**GRU DNAPL Team Comments to:  
Upper Floridan Aquifer Well Installation:  
Investigation of the Northwestern Area of former  
Cabot Carbon/Koppers, Inc. Site (September 14, 2010)  
By DNAPL Team,  
April 19, 2011**

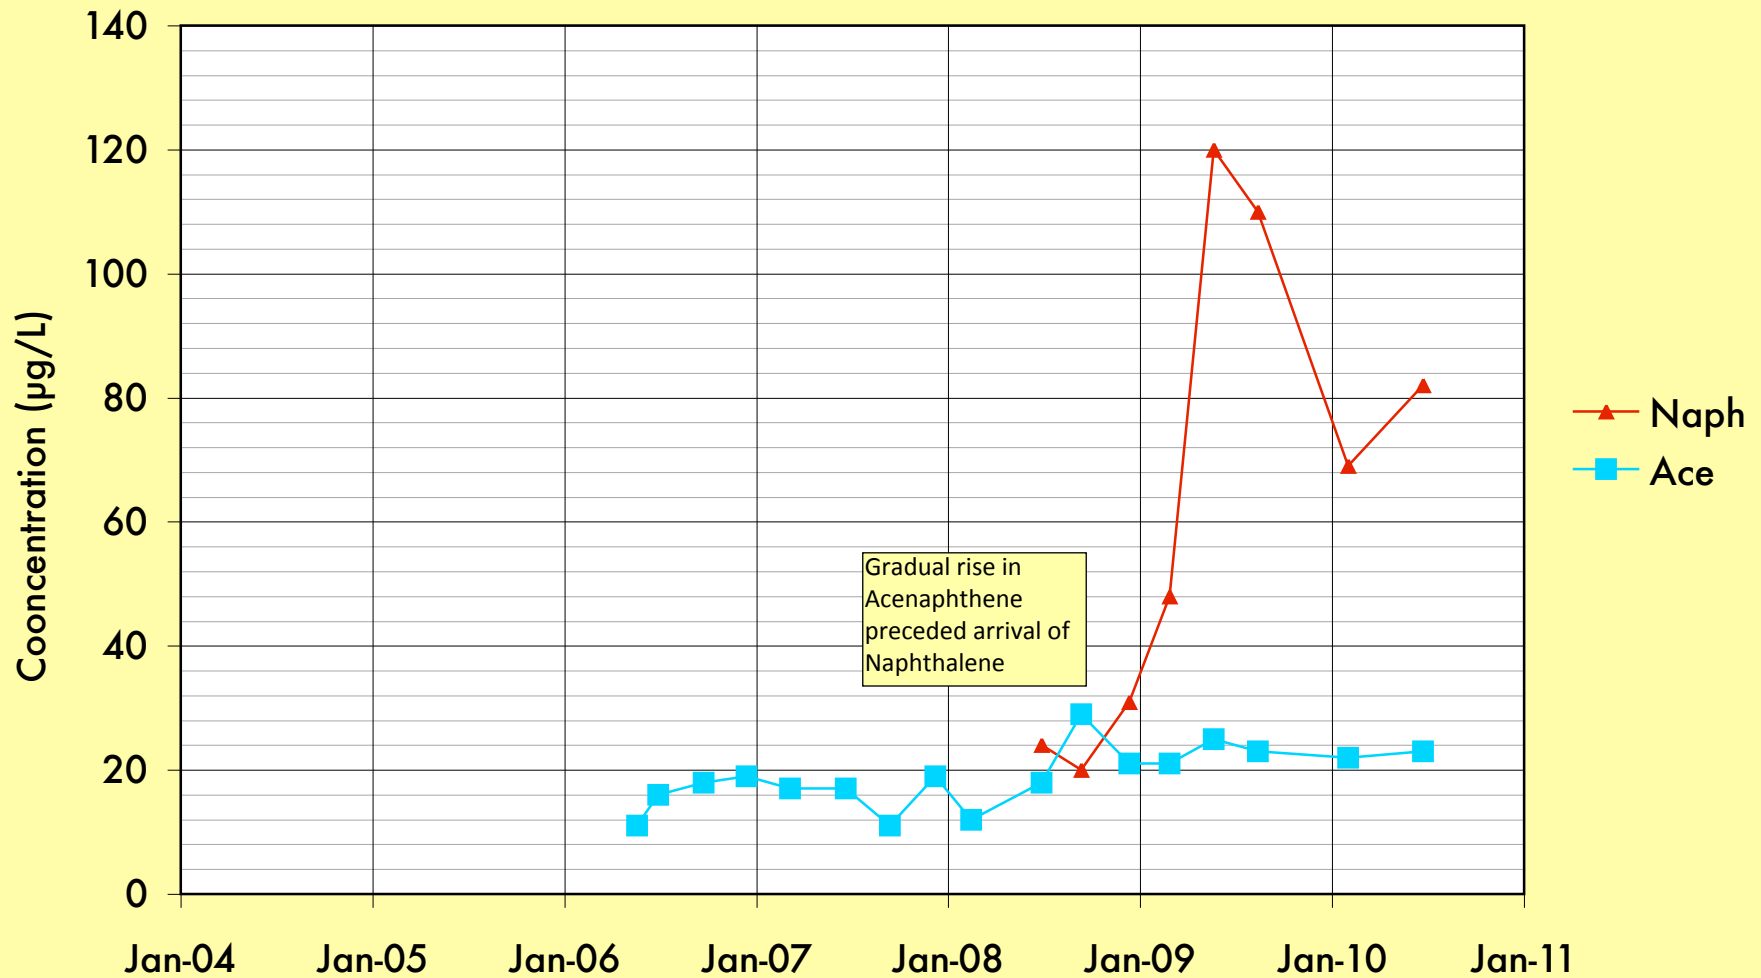
9. Figure 4-6 - On this figure the equipotential lines are draw to slope to the northwest; however no data are plotted on the map to justify these contours and it is unclear from the tables what data this new interpretation is based on. That orientation of the potentiometric surface supports groundwater flow to the northwest at the northwest corner of the site and along the western boundary. This

pattern of equipotentials in this area differs from almost every previous equipotential map drawn for the site and from the GeoTrans groundwater flow modeling which showed equipotentials sloping toward the northeast (see GeoTrans Addendum 7 groundwater flow model report, 2004; FTS equipotential maps for 1st Qtr 2006, 4th Qtr 2006, 1st Qtr 2007, 2nd Qtr 2007; GeoTrans equipotential maps for Dec. 2007, Feb. 2008, June 2008, Sept. 2008, May 2009, Aug. 2009 and Nov. 2009, and Figure 1-8, Upper Floridan Aquifer Potentiometric Surface from the Feasibility Study ). The capture zone drawn extends from FW-22B and FW-31BE toward the southeast back to FW-6 and the north lagoon. If one applies extraction at FW-31BE using the historical grain of the potentiometric surface, then the capture zone would extend to the southwest and would not capture contamination at FW-27B or the North Lagoon.

Jim Erickson clarified that the Upper Floridan potentiometric surface presented in Figure 4-6 is based on the (a) potentiometric surface seen historically and (b) groundwater chemistry, and not on measured water levels. GeoTrans used a northerly slope to the potentiometric surface on the west side of the site presented in previous potentiometric maps (we fail to see that northerly trend or the justification for it) and the belief that the contamination seen in FW-22B, FW-27B, and FW-12B is all coming from the area of FW-6 and the Former North Lagoon. We need more justification for that interpretation than the conjecture presented here. In any case the contours presented in Figure 4-6 should be dashed - in their entirety - and the map and accompanying text should make it clear how the contours were generated.

We would like to see more water level monitoring data to verify the capture zone. We suggest that Beazer supplement the figure with one generated using actual measurements from all wells onsite, the measurements being conducted when FW-31BE is being pumped at the expected long-term rate of 23 gpm.

## Groundwater at Monitoring Location FW-23B-Z3 at Northern Property Boundary

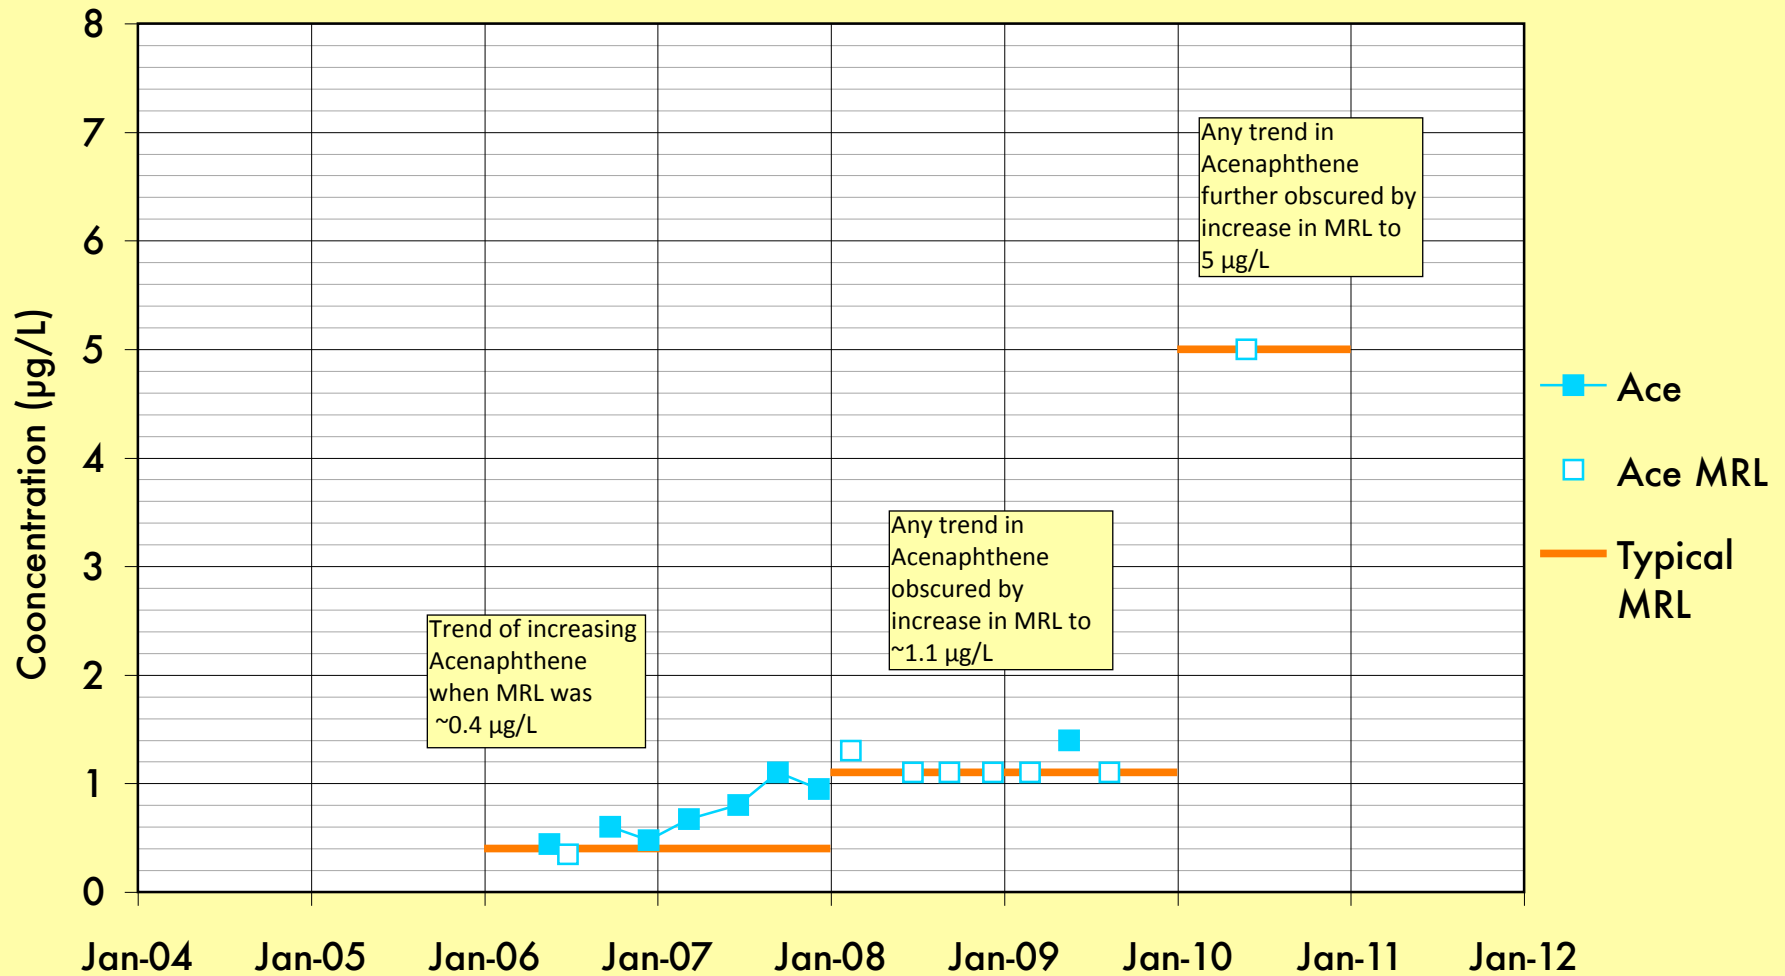
Arbitrary increases in the MRL (method reporting limit) for Acenaphthene obscure potential early-warning of subsequent increases in Naphthalene at the property boundary.

### Groundwater at Monitoring Location FW-24B-Z3 at Northwest Property Boundary

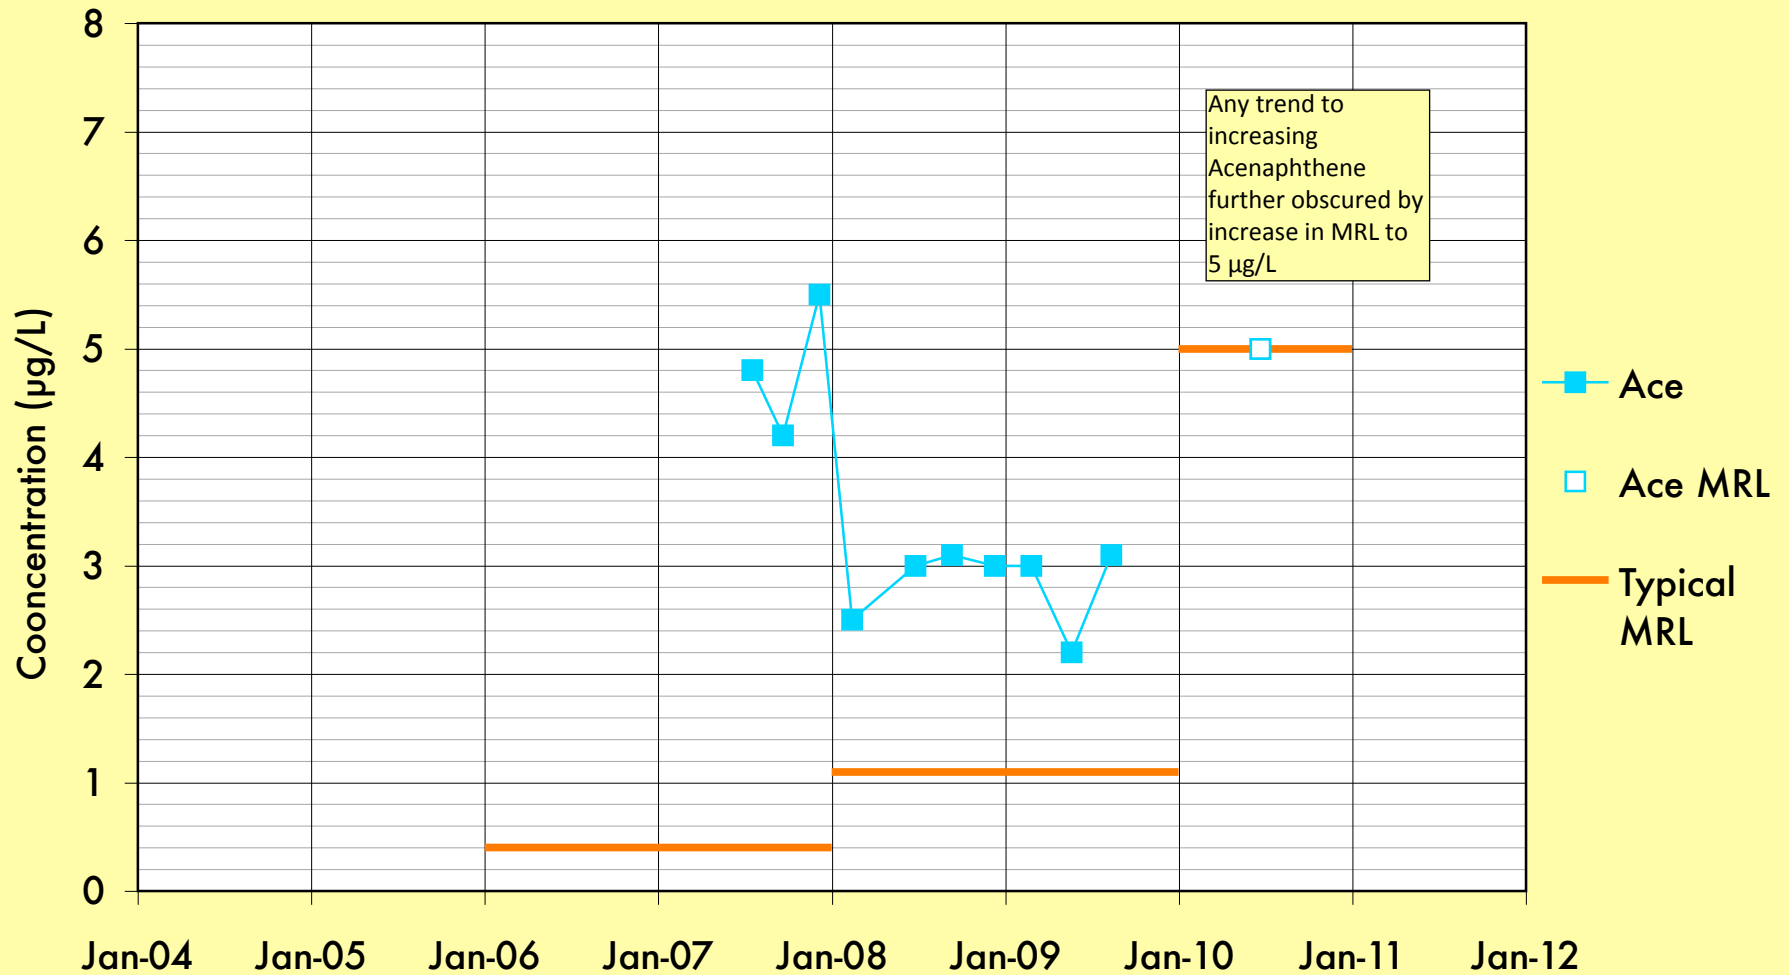
Arbitrary increases in the MRL (method reporting limit) for Acenaphthene obscure potential early-warning of subsequent increases in Naphthalene at the property boundary.
